Creek Wearable Technology Co., Ltd.

Ref: FCC Class II Permissive change for FCC ID: 2BBYH-C1023

This is to request a Class II Permissive change for FCC ID: 2BBYH-C1023 originally granted on 12/21/2023 (date).

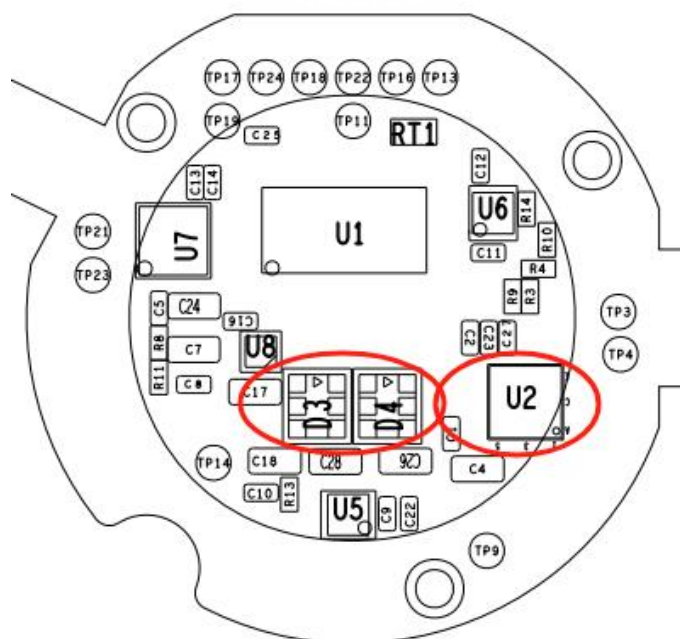
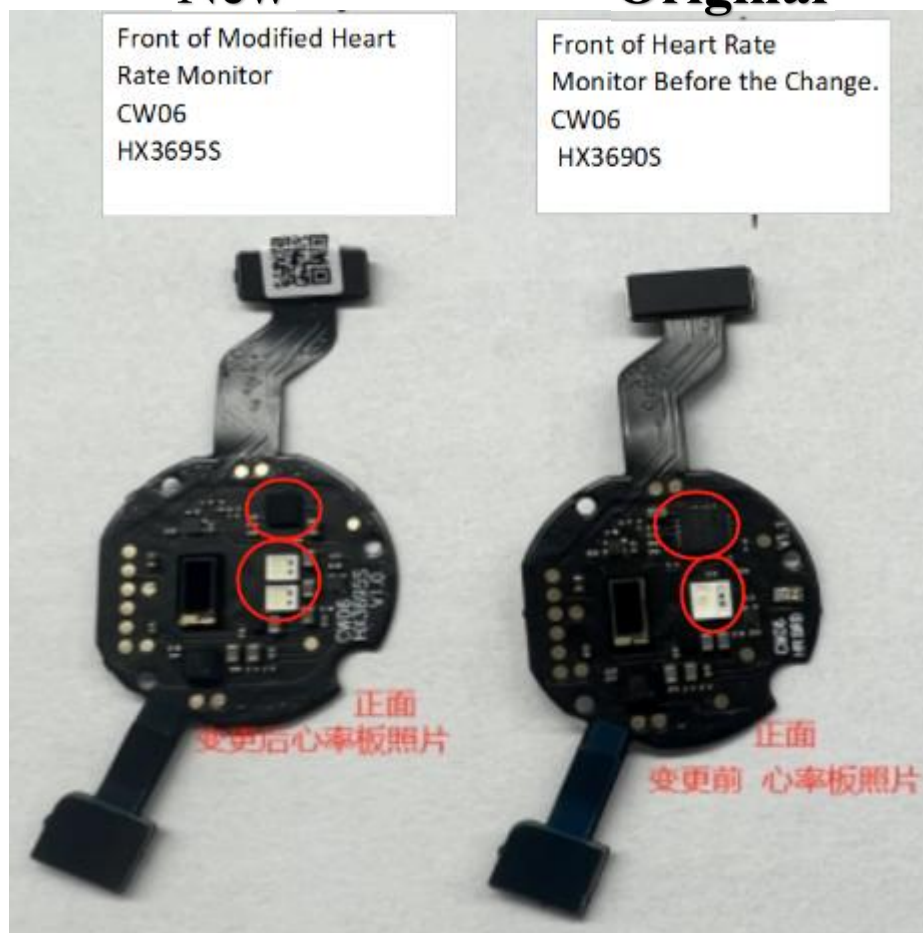
- 1, Heart rate board added material IC.HX3695S. Replace the original scheme IC.3690Si;
2. The heart rate board added D3 and D4 to replace the original U3;
